#### SUBDIVISION REVIEW SHEET

**SUBDIVISION NAME:** Gullahorn, Phase 1A Preliminary Plan

## CITY OF AUSTIN – TRAVIS COUNTY – SINGLE SUBDIVISION OFFICE SUBDIVISION APPLICATION – MASTER COMMENT REPORT

PROJECT NAME: Gullahorn Subdivision, Phase 1A

**4** OF **13**

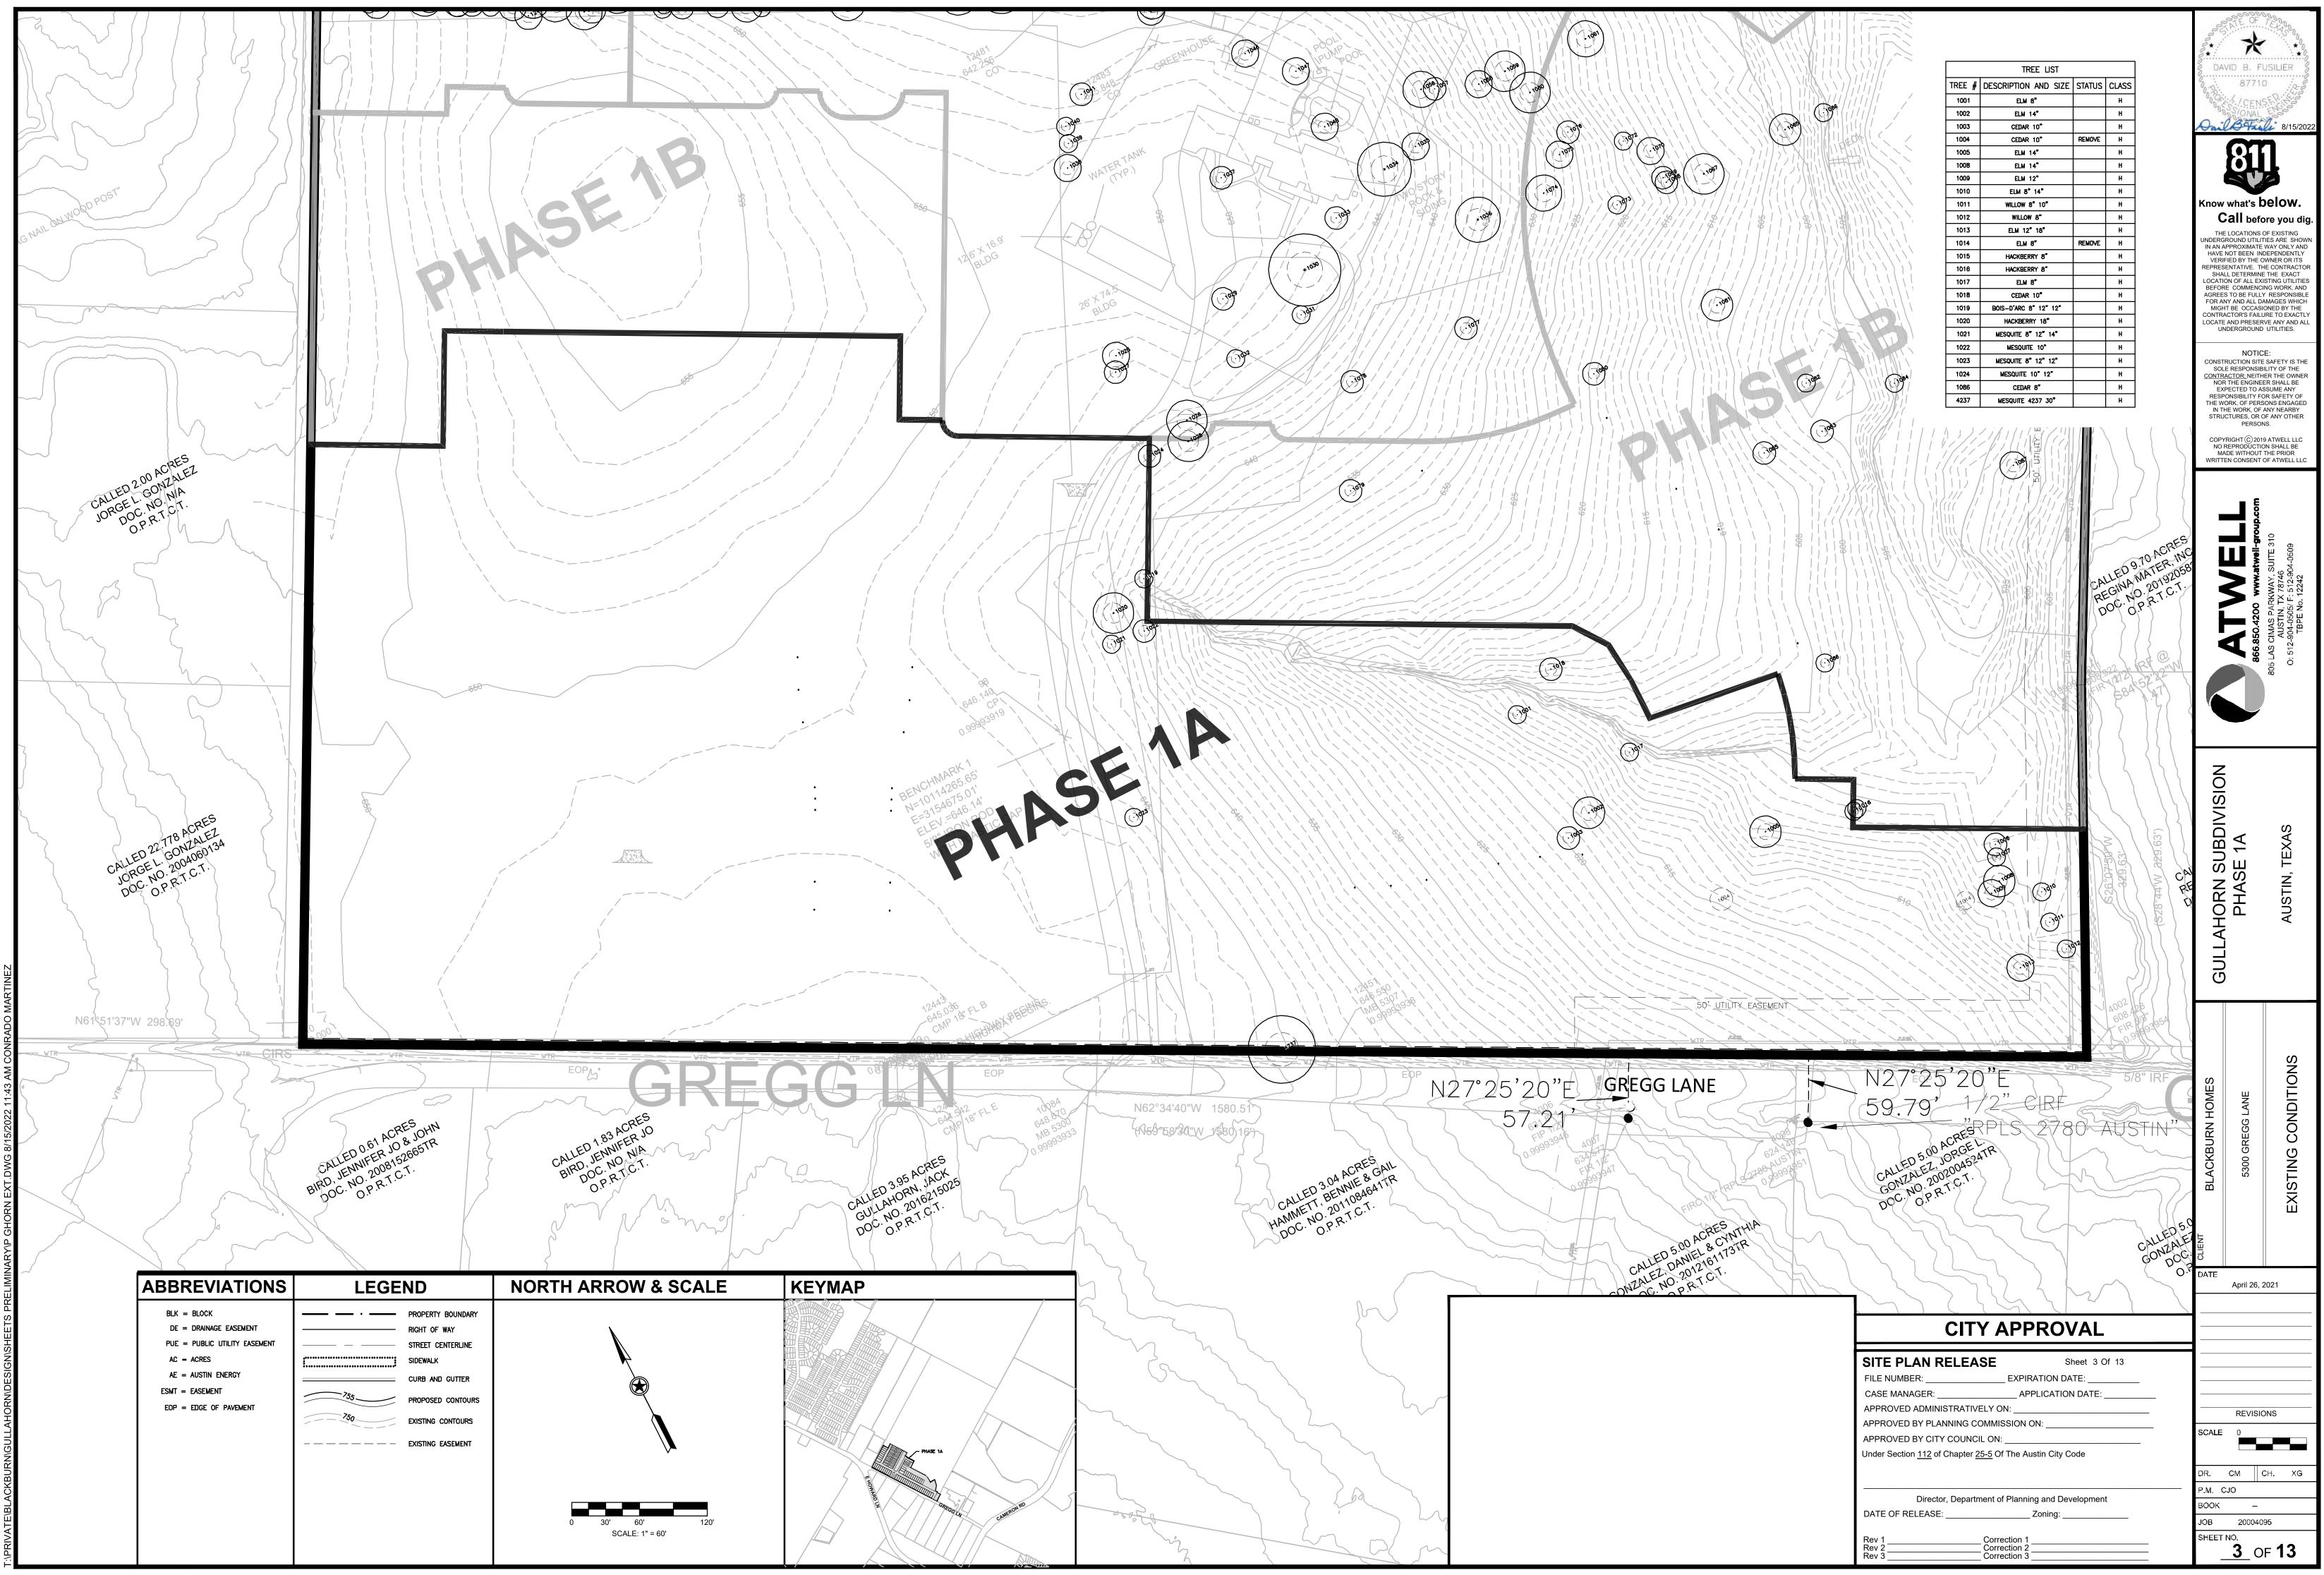
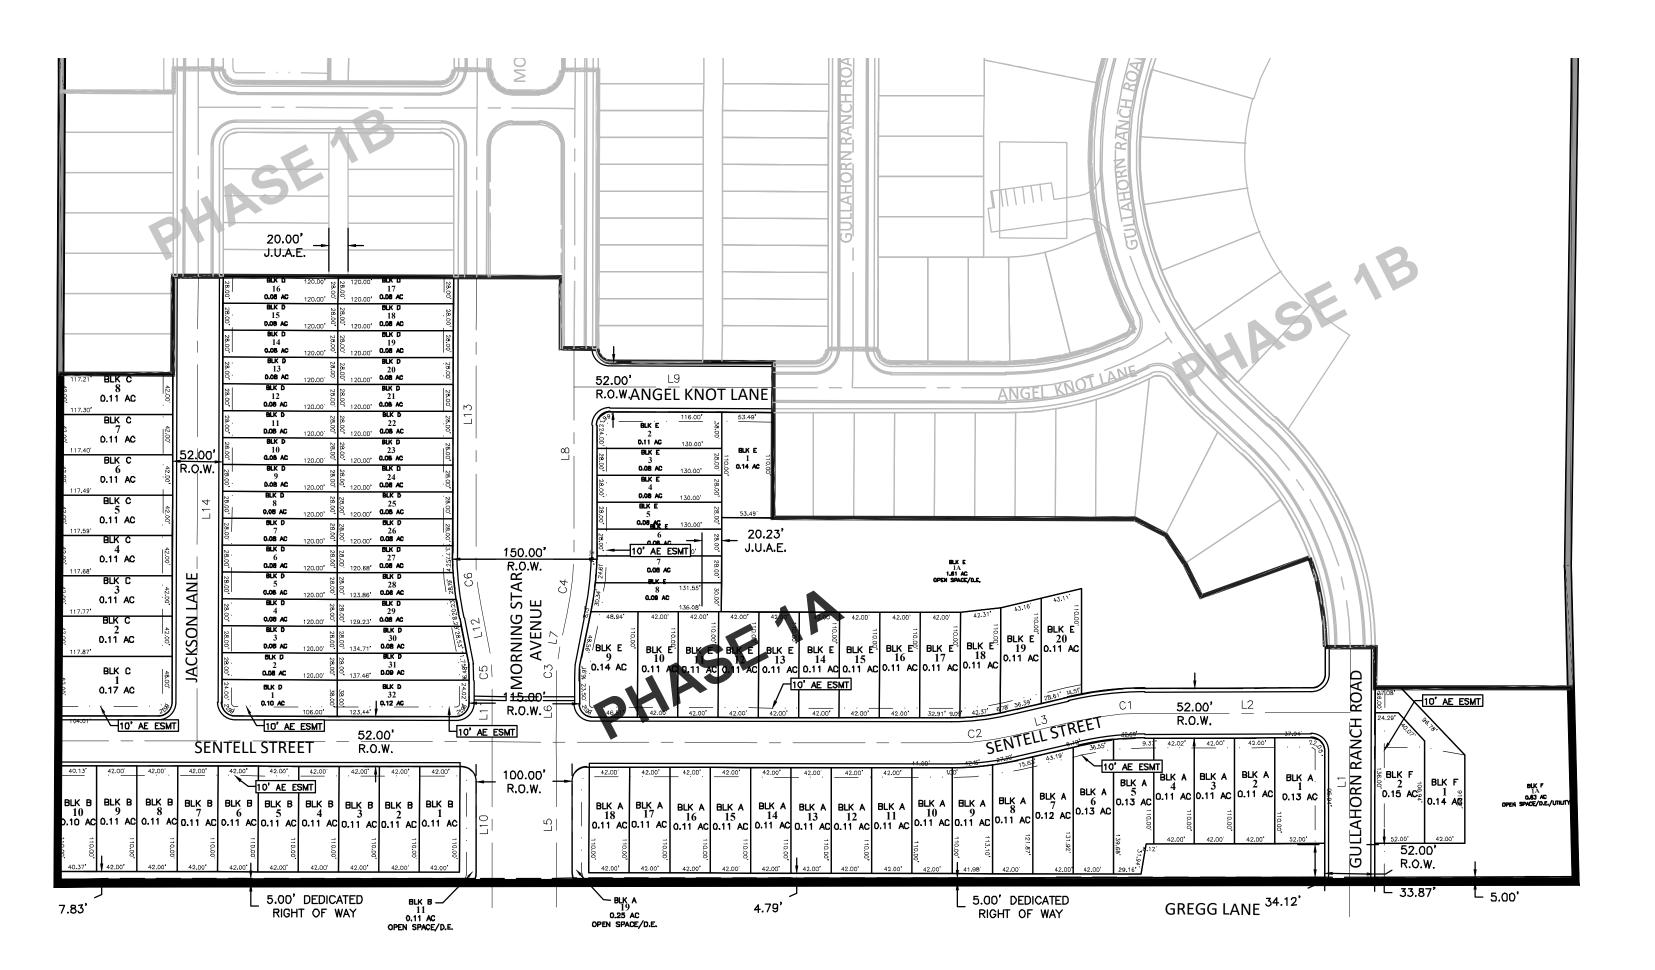
- e. Sidewalks need to be shown as a dotted line along the ROWs and shown in the legend. Example: Sheet 4 Overall layout page.
- 17. Provide the letter from E-911 addressing verifying the proposed street names have been approved for this subdivision. COA Addressing also wants to be informed of all new streets and any street realignments, and vacations/abandonments (including dedications by separate instrument, by deed, etc.). They need to be contacted during the review process. The contact for this portion is Cathy Winfrey at 974-2398 or cathy.winfrey@austintexas.gov

- a. Pending. Survey ties not found.
- b. A survey tie completely across showing the other side of Gregg Lane's boundary should be shown. Example: Sheet 4 Overall layout.

- 21. Please include Travis County's approval block in the blank space.
- 22. Please show the temporary turnaround easements on all pages. Example: Sheet 4 Overall layout.
